Project
PROPOSED DEVELOPMENT AT
BALTONSBOROUGH
GLASTONBURY
SOMERSET

Drawing Title
Plots 51-52
Proposed Plans & Elevations

DWG No. 4424-51-52-P01 Rev. -

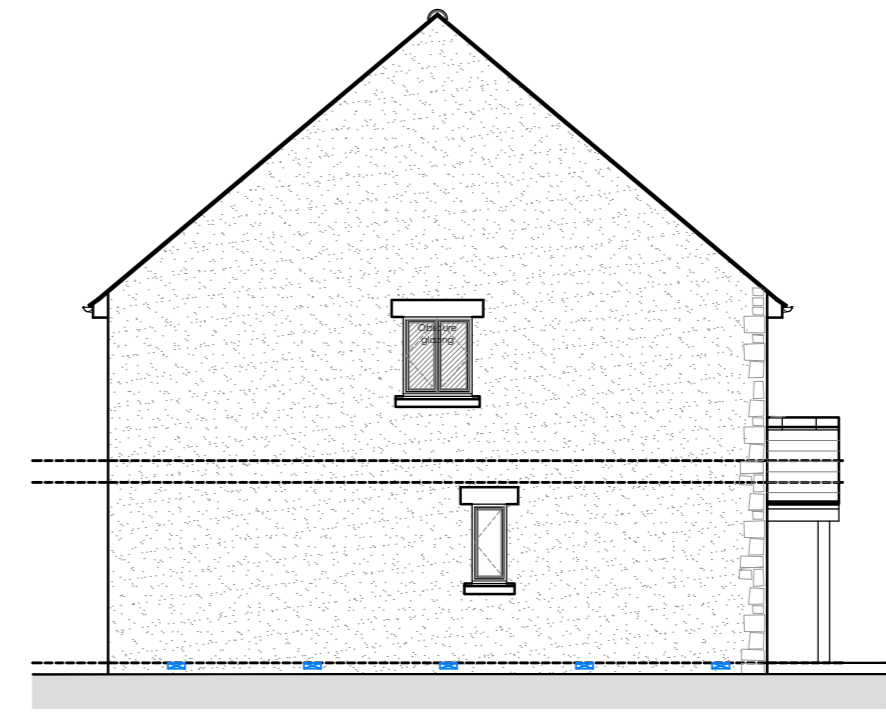
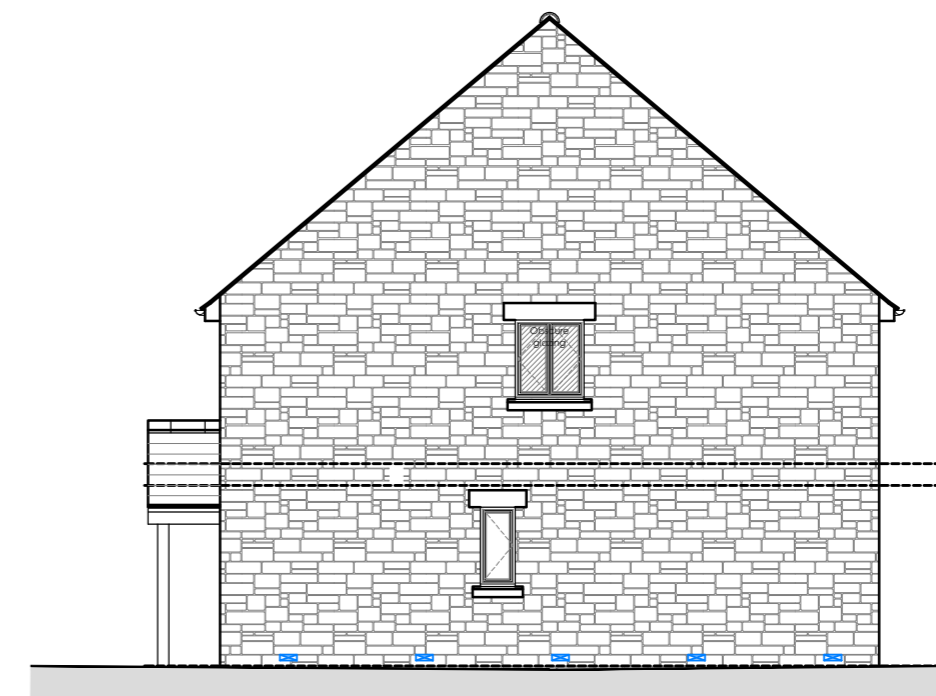
- East, South & West elevations changed from render to natural stone.
- Stone plinth omitted.
- Lean to porch omitted & replaced with individual timber porches & brick walls.
- Brick arch window heads omitted and replaced with natural stone lintels.
- Cast stone window cills added.
- Side Elevation small windows at loft level omitted.
